Master
Development
Drainage
Plan /
Preliminary
Drainage
Report

Eagle Rising

Project No. 61145

PCD File No.: SP205

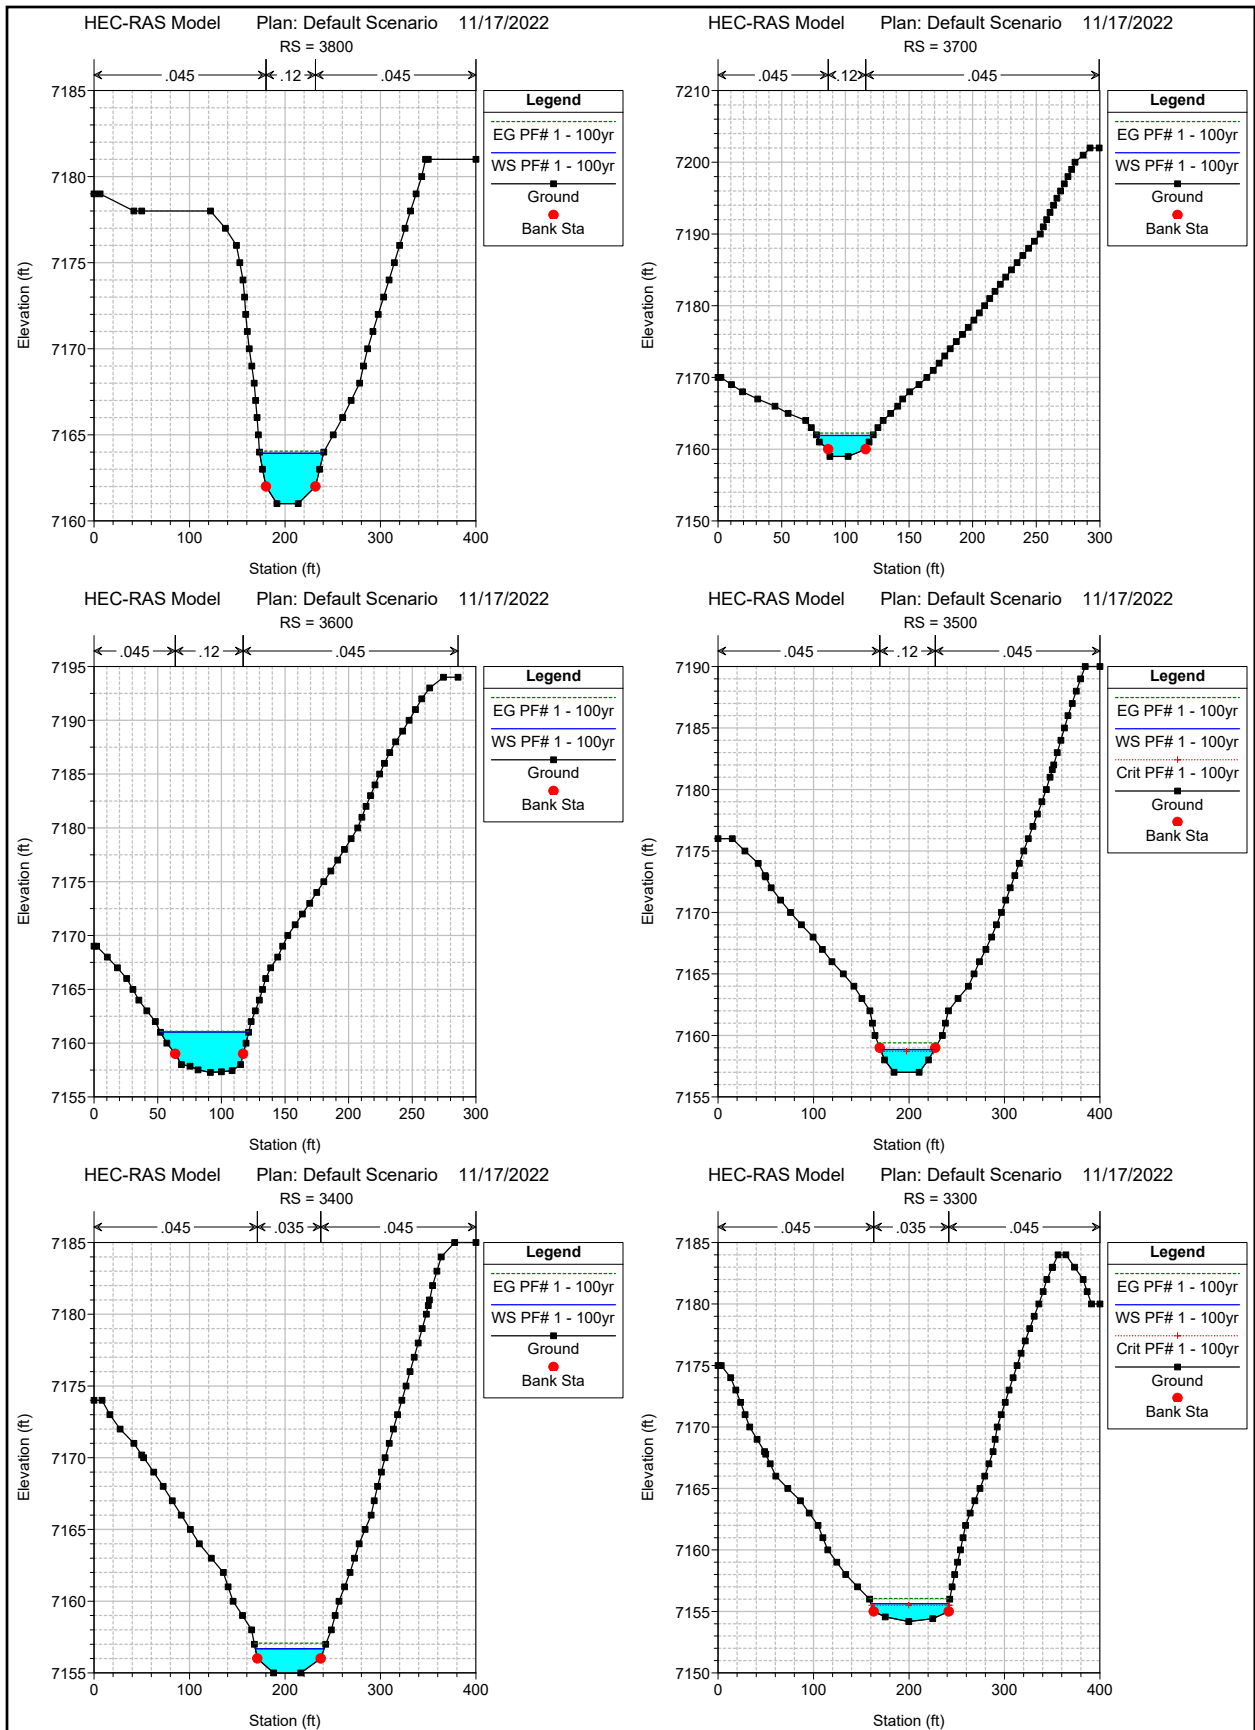
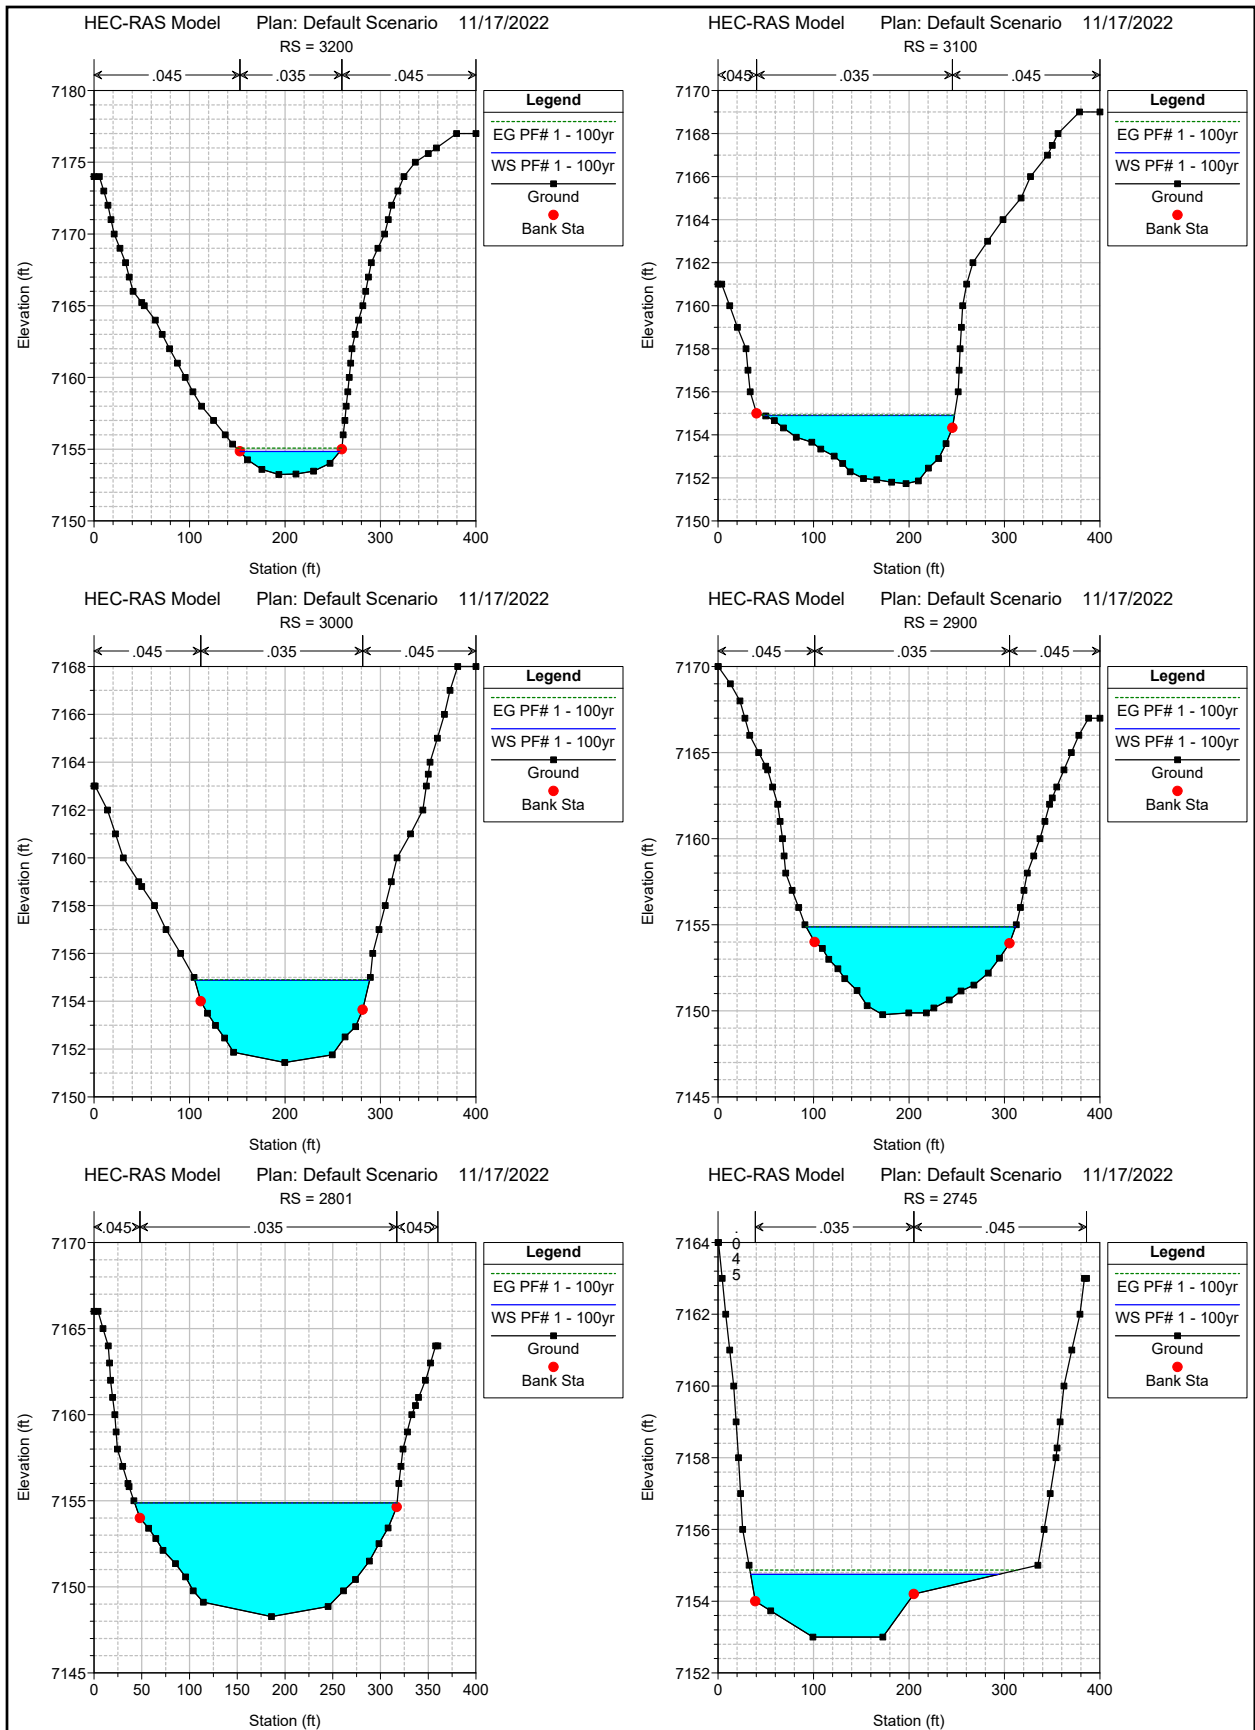
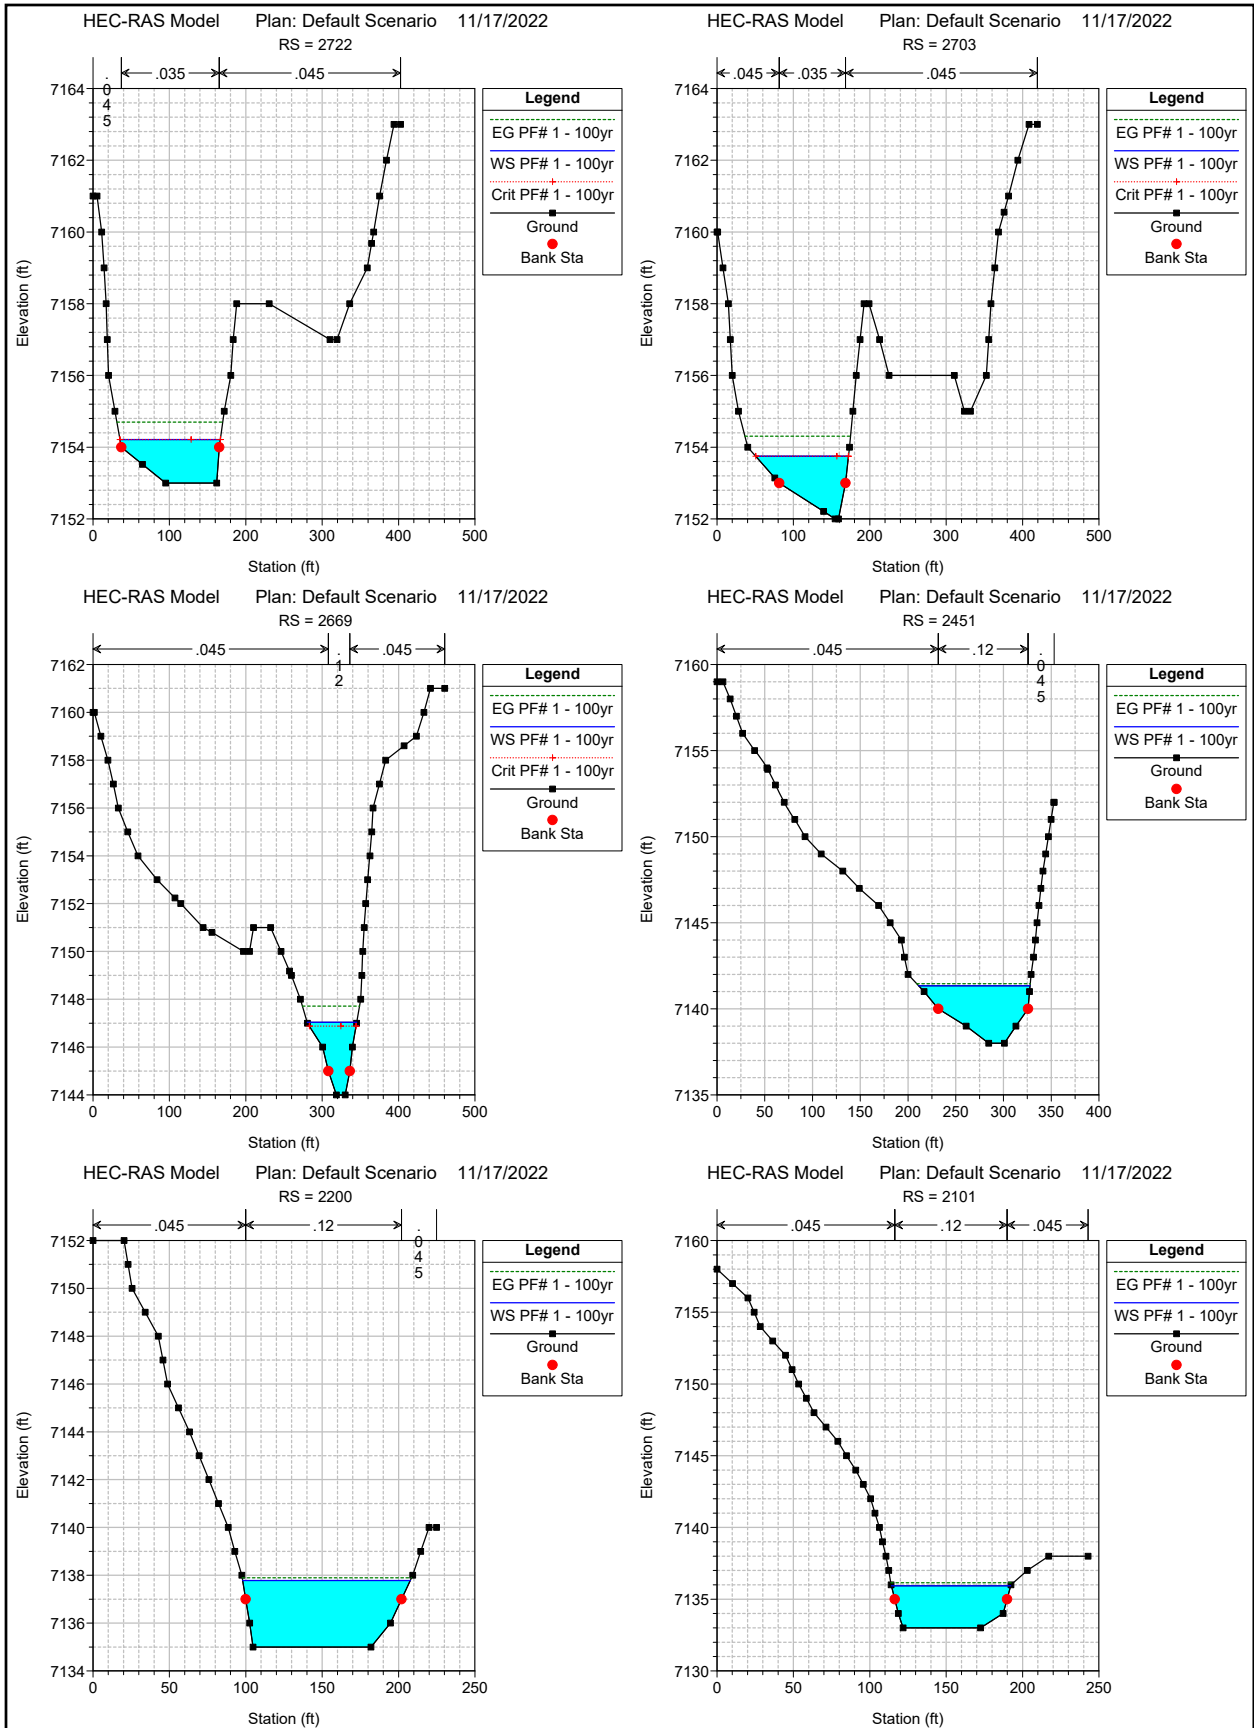
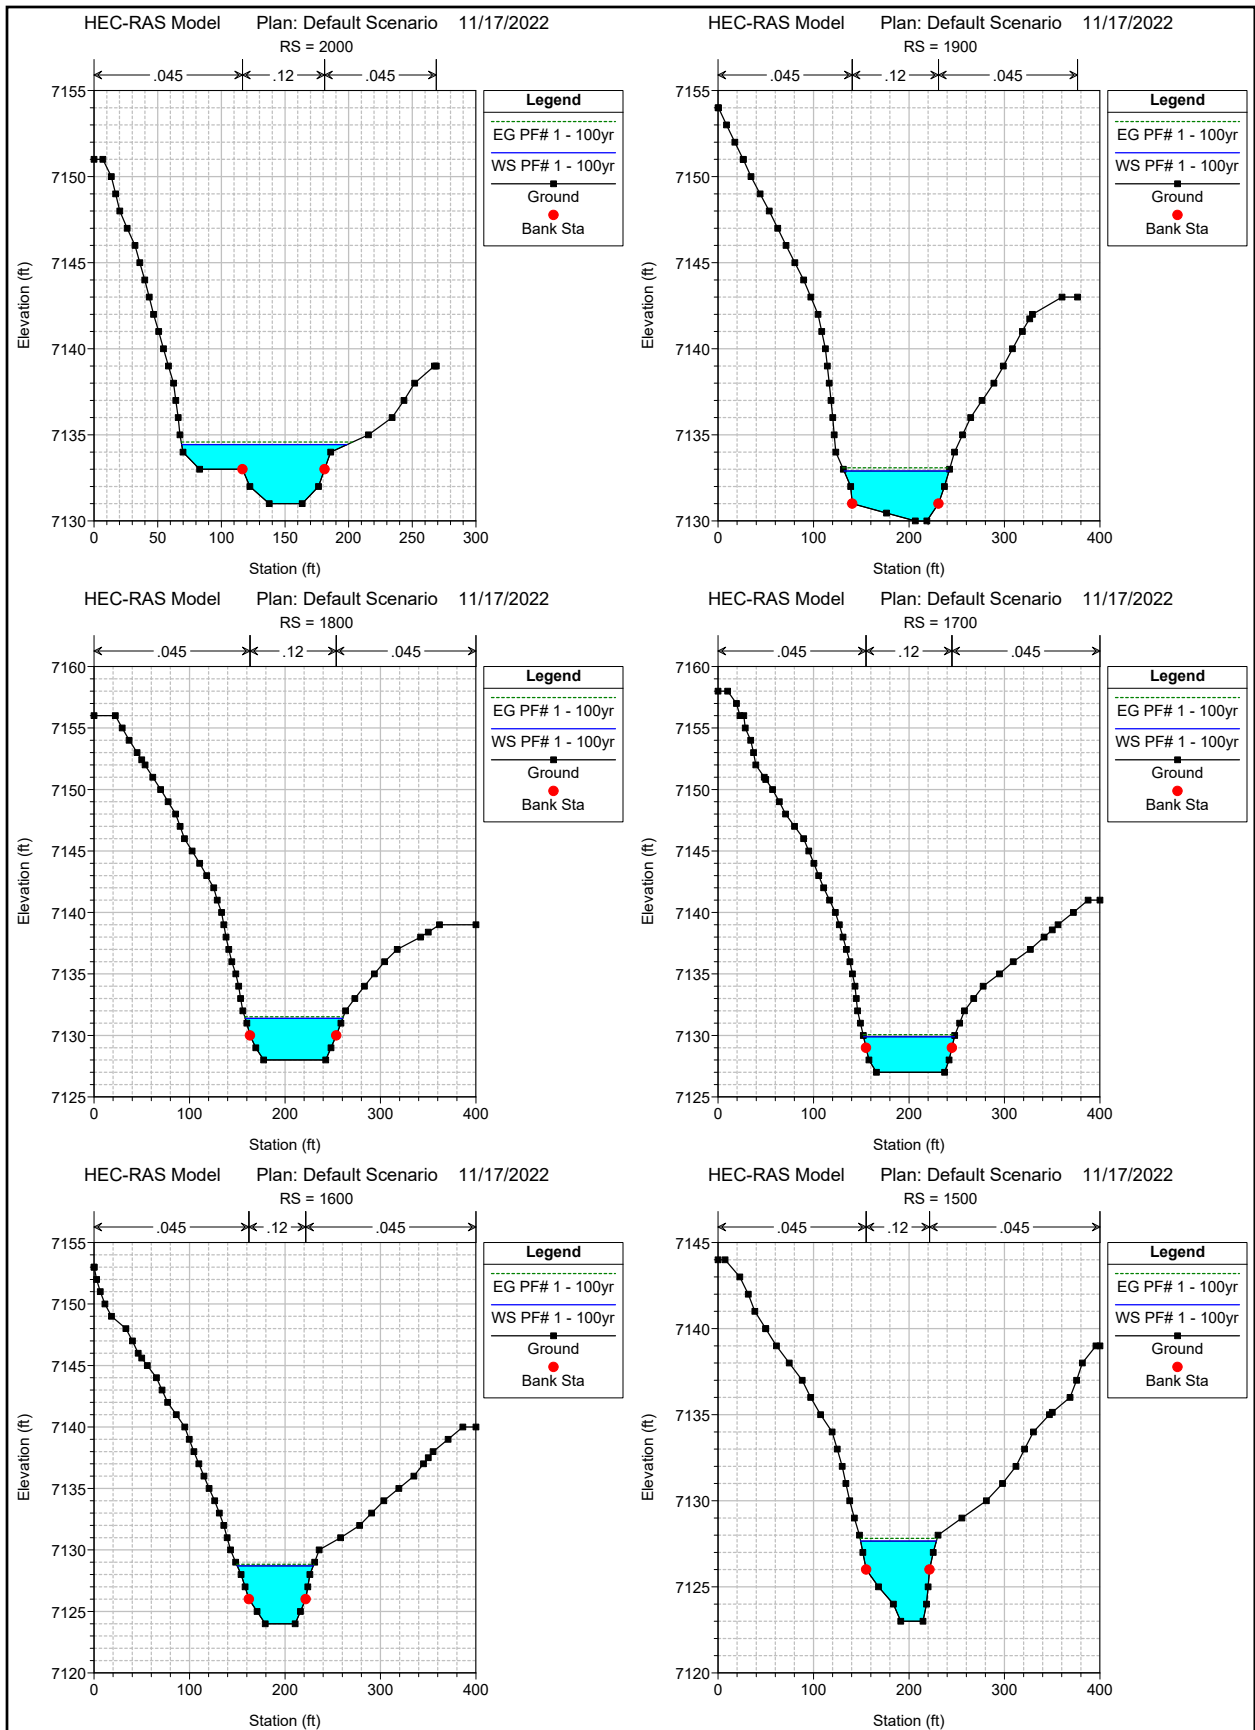
Provide plan detail
